PUBLIC HEARING MEMORANDUM

SUBJECT: **Petition #430-16**, for SPECIAL PERMIT/SITE PLAN APPROVAL to change a nonconforming clubhouse use to multi-family use, to allow parking within the front setback, and to allow an entrance and exit drive less than 20 feet wide at **15 South Gate Park**, Ward 3, on land known as SBL 33, 31, 9, containing approximately 14,120 square feet of land in a district zoned SINGLE RESIDENCE 3. Ref: 7.3.3, 7.4, 3.4.1, 7.8.2.C.2, 5.1.8.A.1, 5.1.13, 5.1.8.D.1 of the City of Newton Rev Zoning Ord, 2012.

15 South Gate Park

*Proposed Conditions Site Plan
15 South Gate Park
Newton, MA
Prepared by: Verne T. Porter, Jr., PLS
Dated: June 8, 2015
Revised: September 17, 2015*

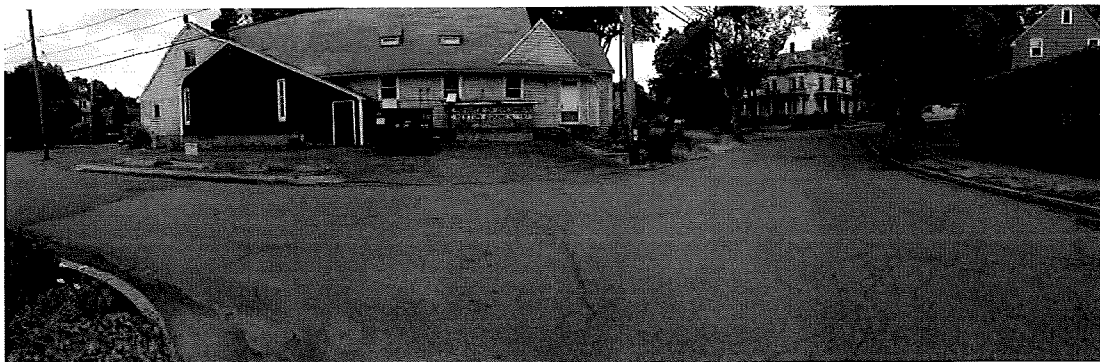
The proposed project is a 4 unit attached dwelling with underground and surface parking located on a 14,120 square foot lot currently occupied by the Knights of Columbus Hall. The site is essentially all impervious except for a grassy area on the north side of the lot. No drainage study was submitted for review. The plan indicates the access ramps are sloped at 8% & 4% respectively down gradient to the underground parking facility, this cannot be confirmed without the proposed grades; to clarify this, proposed finished grades are needed along the top, and bottom of the ramp. The driveway scales approximately 10' wide, which is not wide enough for two way traffic; traffic signals

have been added at the entrance and exit the underground garage to accommodate safe passage. The proposed retaining wall that is parallel to the ramp needs grades and elevations as well as material specification; and will need a safety fence per Building Code.

An automobile turning template plans is needed on the engineered scaled site plan to demonstrate that this design actually works; the drawing on sheet A-2a just shows a generic vehicle without turning radius. The movements should be for entering and exiting the garage as well as within the garage.

All drainage within the interior of the garage must be connected to the sanitary sewer yet there is nothing shown to reference this. Three curb cuts seems a bit excessive for one lot, the engineer of record should reconsider and consolidate the total number of curb cuts. Snow storage needs to be identified, how will trash & recycling be addressed?
